DRN	JMM	5/14/2021	WUSM RESEARCH BUILDING
CHK			NRB CUP
APP			LVLO2 SPOOLS
JOB NO.	210140	SERVICE NAME	HWR HRC
REF.DWG.			
DRAWING NO./TRACKING NO.	210140-A-UPL2-4-10	QTY.	1
		SHT/NO	1 of 1
		REV	0

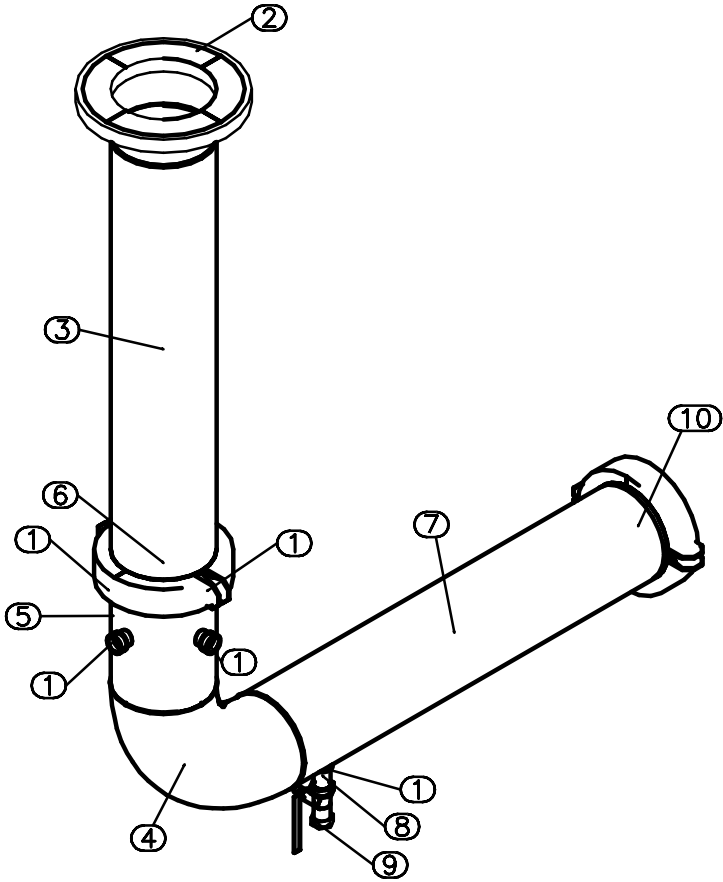
QTY 4 ON THE QUADRANTS

should be an Apollo  
77C-140 Series  
Ball valve
